**REQUEST**

Current Zoning: R-3 (single family residential)  
Proposed Zoning: R-8MF(CD) (multi-family residential, conditional)

Approximately 20.88 acres located along the southeast side of Mallard Creek Road and north of Morris Estate Drive.

The petition proposes to allow up to 130 townhouse style dwelling units for a density of 5.7 dwelling units per acre on vacant land.

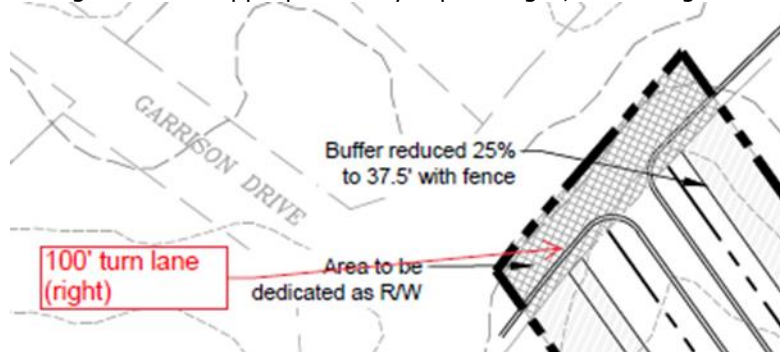
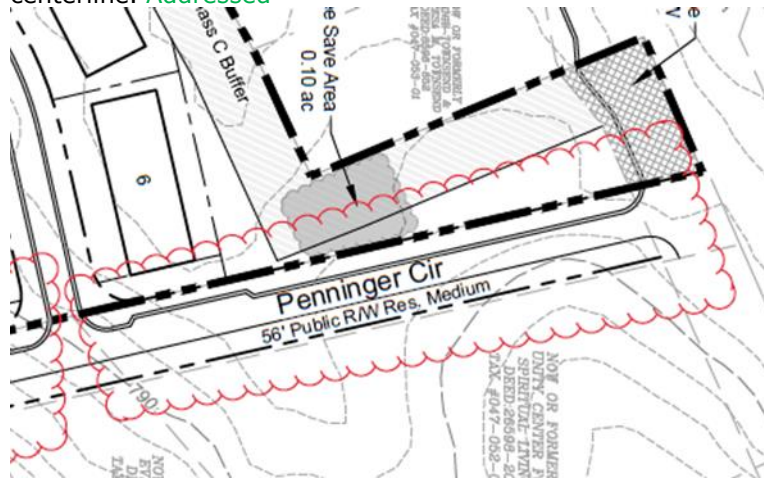
4. **Technical Clarification (site plan dated 09/14/20) The petitioner should clarify whether front-loaded or rear-loaded units are proposed. If front-loaded, the petitioner should commit to pair shared driveway aprons with every two units, to preserve the proposed planting strip and sidewalk within the public right of way. This request limits the number of curb cuts, and promotes walkability, and preserves a quality streetscape.**

6. **Technical Clarification (site plan dated 09/14/20) The petitioner should clarify the site plan to show and call out the existing Penninger Circle private drive that ties into existing Mallard Creek Road. CDOT requests the petitioner to clarify that the existing Penninger Circle road**

improvements will be constructed in accordance with CLDSM U-02—Local Residential Medium Section cross section design standards, on both sides of the existing Penninger Circle road centerline. Addressed
